Proposal for Parallel SCSI: Increase Transfer Rate and Improve Error Detection

To: T10 Technical committee
From: Jim McGrath
Quantum Corporation
500 McCarthy Boulevard
Milpitas, CA USA 95035
Phone: 408-894-4019
Fax: 408-952-3620
Email: jim.mcgrath@quantum.com
Date: ~~August 17~~ July 11, 1998

Rev 4

Figure 2 -- CRC_AVAILABLE timing

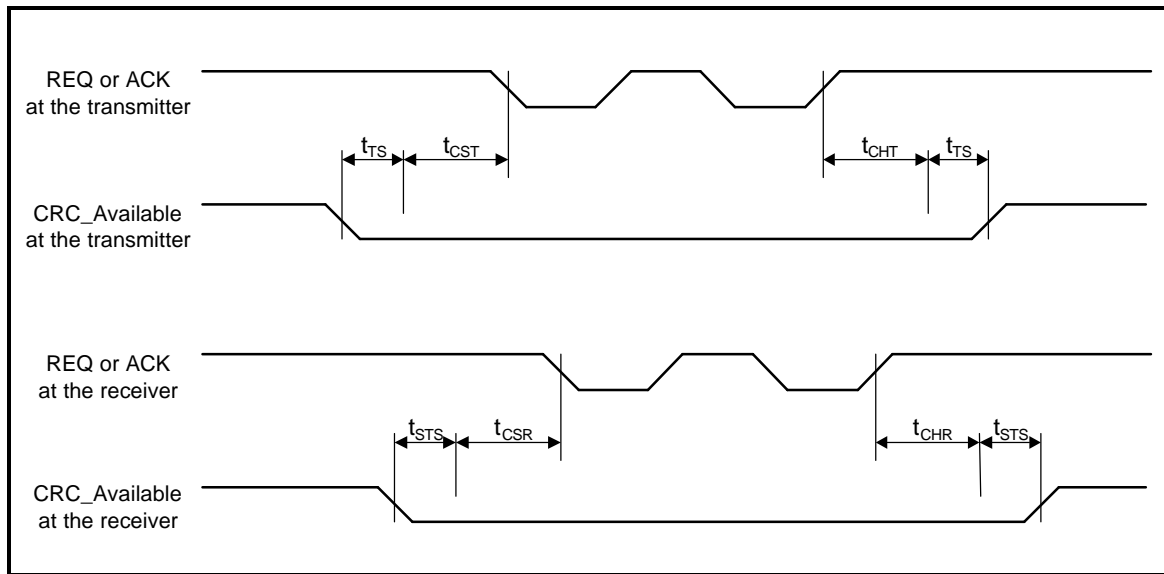
[Note: in the second t_{ST} , there should be additional setup time to allow CRC_AVAILABLE to transition. Following the precedence for setup to CRC_AVAILABLE, it is suggested that an extra 10 ns setup be added here. – CC_AVAILABLE setup time is 10 ns additional on either assert or deassert with request to REQ.]
